CDM: Recommendation Form for Small Scale Methodologies (version 01)

Date of SSC WG meeting:	24–27 February 2009, SSC WG 19
Title/Subject (give a small title or specify the subject of your submission, maximum 200 characters):	Revision of AMS-III.Q to allow new captive plants
Indicative methodology to which your submission relates (refer the items of Appendix B of the Simplified Modalities and Procedures), if applicable.	AMS-III.Q version 02
Name of the authors of the query:	Takeshi Miyata Institution: Mitsubishi UFJ Securities Co., Ltd. miyata-takeshi@sc.mufig.jp

Diagrammatic representation of Existing Facility:

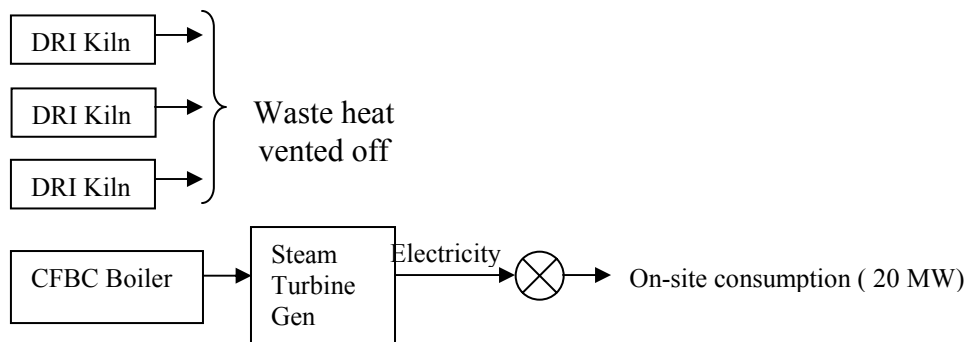
The SSC WG agreed to clarify that in principle the applicability of AMS-III.Q can be broadened to include new captive power plant in the baseline in the existing facility. However, the SSC WG noted that the current version of the methodology does not provide guidance on determining baseline fuel/scenario. As an example, no guidance is provided to demonstrate that the baseline is not the grid (e.g. due to its poor reliability), but a hypothetical captive plant that would have been built in the absence of the project activity.

The project proponent may consider submitting a request for revision considering elements from ACM0012 and including guidance specifying situations under which the grid cannot be considered as the baseline although the plant is grid connected.

Diagrammatic representation of Proposed Baseline (hypothetical):

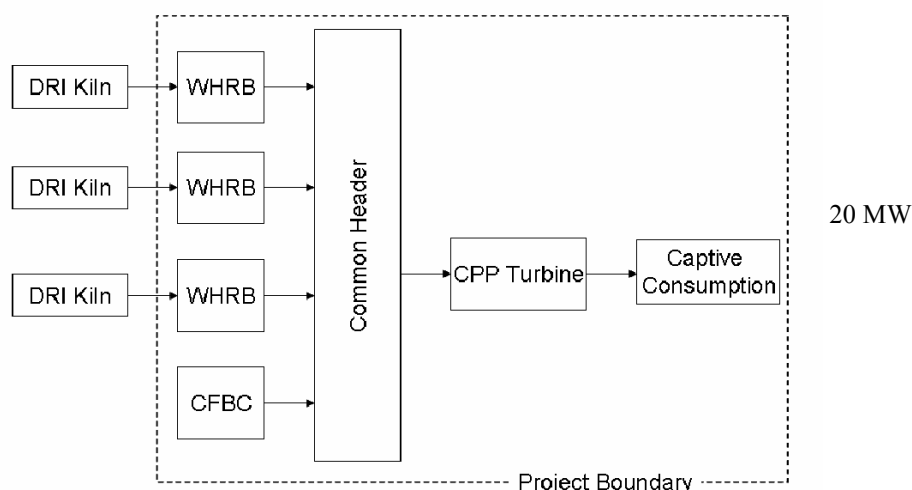
Since for the project developer, generation of the required steam through a larger CFBC boiler with a capacity of 85 THP (and no WHRBs) is more economically attractive proposition than to develop the Project, in absence of the proposed CDM project activity (a smaller CFBC boiler with a capacity of 75 TPH and three WHRBs) the developer would build a larger CFBC boiler with a capacity of 85 TPH. Therefore, the CFBC boiler with a capacity of 85 TPH should be considered as the baseline, while power generated from the WHRBs under the Project activity will reduce emissions that would have been emitted

However, the current methodology AMS-III Q Ver. 2 does not allow a new captive power plant to be the baseline, as equation (2) excludes new captive power plant. Considering the fact that ACM0012 ver. 3.1 equation (1a-11), which is same as the equation (2) of the AMS-III Q ver.2, allows to be applied for a new captive power plant, it is reasonable to amend the AMS-III Q ver. 2 to allow new captive power plant. In addition, paragraph 9 should be amended to include new captive plant, accordingly.
